WALDEN PRESERVE

DEVELOPED DRAINAGE, GRADING
& EROSION CONTROL PLAN

SHEET: D1

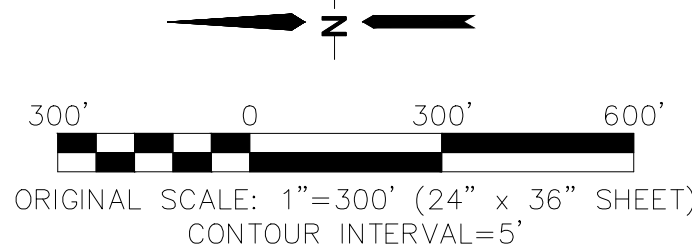
Since the lots are less than 2.5 acres WQCV is required. Per the MS4 permit water quality treatment must be provided for 100% of the applicable development site. The exclusion from WQCV only applies to residential lots greater than or equal 2.5 acres and having a total lot impervious area of less than 10 percent. The area highlighted in yellow does not go through any WQ BMP.

Update the drainage map to reflect the submitted plat and pud amendment application.

1. Address WQ treatment for the small portion in filing 4 in Final Drainage Report.
2. Under the PUD application, submit a revised MDDP or an addendum to the original MDDP addressing WQ for the remaining areas.
